Architectural Review Board Staff Report

Meeting Date: April 6, 2023
Report #: 2303-1194

3300 El Camino Real [21PLN-00028]: Ad-Hoc Committee Review of Previously Approved Project to Review Architectural and Landscape Element Design Changes

10/20 Submittal

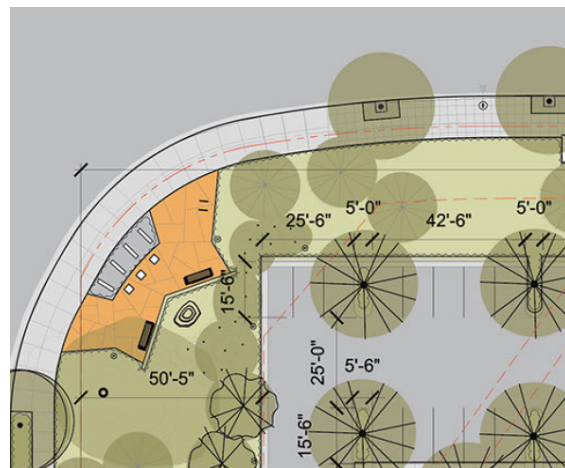
The ARB recommended that the applicant enhance their landscape plan along the El Camino Real Frontage to incorporate a linear park to activate the street and better respond to El Camino Real Design Guideline 2.3.1.2 and 3.2.5.

The applicant has expanded the size of the corner pedestrian plaza at Hansen Way and El Camino Real and added fixtures to attract pedestrians to use the space. However, to create a linear park, staff would suggest the applicant add a decomposed granite (DG) walkway from the corner plaza to the front entrance plazas. The applicant has stated this is infeasible.

See the attached drawings for refinements to the landscape strip design along El Camino Real.

10/20 Submittal

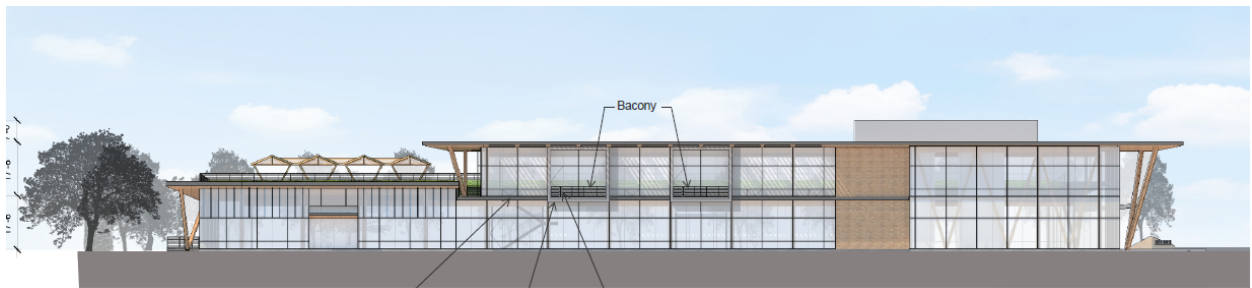
The ARB recommended that the applicant modify their existing façade on El Camino Real to incorporate additional textures to add additional articulation to the street facing side of the building.

See the attached drawings for the proposed changes to the façade facing El Camino Real. Two new framed balconies are proposed on the second floor that provide for greater articulation and visual texture to the façade.

The applicant has provided the requested modifications.

4/6 Submittal

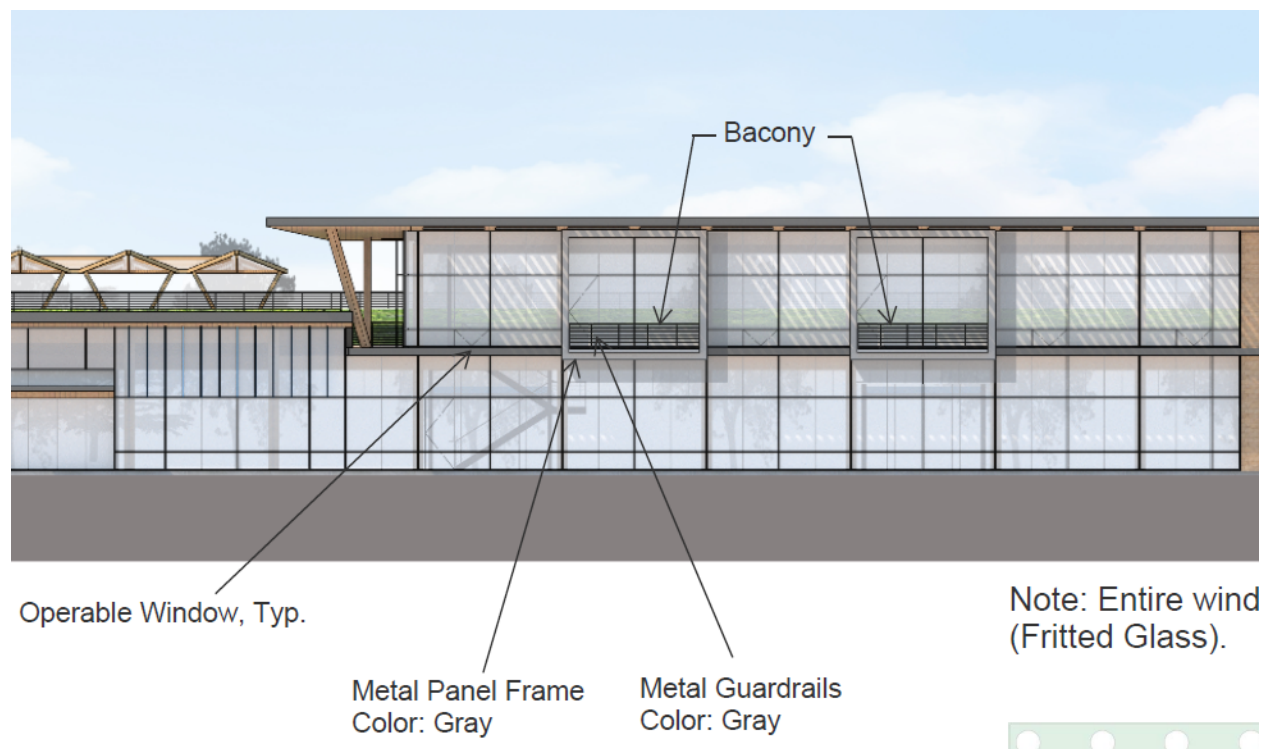
The ARB recommended that the applicant incorporate operable windows into the design of their building.

The applicant has provided the requested windows on the El Camino Real façade. There does not appear to be any added windows on other façades.

See attached drawings for the proposed locations of the added operable windows on the second floor along the El Camino Real façade.
